# Access Compliance Report

## Public Rights-of-Way

### (Curb Ramps)

Intersection ID: 45886	Main Street: BEN_LIVINGSTON_RD	Cross Street: OAK_ST	Location:	S
ADA ID: CFDA6886A100	Ramp Type: Perp	Initial Pass/Fail: Fail	Overall Compliance: No	Severity Score: 10
Codes/Mitigation Info/Possible Solution		Field Measurements/Component Compliance

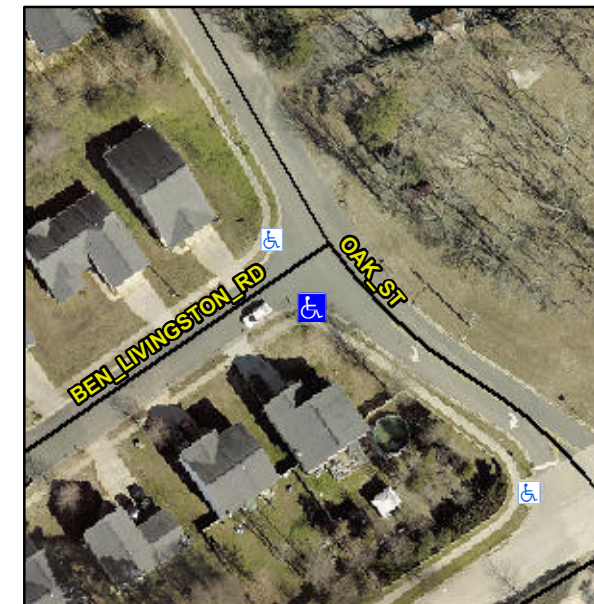
**Remove & Replace Entire Ramp.**

**R304.5.1, R304.5.3**

Compliance	Description	Data	Compliance	Description	Data
N/A	Ramp Length (in)	47.0	Yes	Ramp Slope (%)	7.5
No	Ramp Width (in)	47.5	No	Ramp XSlope (%)	3.4
N/A	Flare Type LT	N/A	N/A	Flare Type RT	N/A
N/A	Flare Slope LT (%)	N/A	N/A	Flare Slope RT (%)	N/A
N/A	Flare Traversable LT?	N/A	N/A	Flare Traversable RT?	N/A
N/A	Landing Length (in)	N/A	N/A	DWS Provided?	N/A
N/A	Landing Width (in)	N/A	N/A	DWS Contrast?	N/A
N/A	Landing Slope (%)	N/A	N/A	DWS Length (in)	N/A
N/A	Landing X Slope (%)	N/A	N/A	DWS Full Width?	N/A
N/A	Landing Curb? (Y/N)	N/A	N/A	DWS Offset (in)	N/A
N/A	Shared Landing?	N/A			
N/A	Gutter Ponding?	N/A	N/A	Gutter Slope (%)	N/A
N/A	Gutter Lip Ht (in)	N/A	N/A	Gutter X Slope (%)	N/A
N/A	Painted X Walk1?	No	N/A	Painted X Walk2?	N/A
	X Walk 1 Direction	To N		X Walk 2 Direction	N/A
N/A	X Walk 1 Width (in)	N/A	N/A	X Walk 2 Width (in)	N/A
	X Walk 1 Slope (%)	2.3		X Walk 2 Slope (%)	N/A
	X Walk 1 X Slope (%)	3.6		X Walk 2 X Slope (%)	N/A
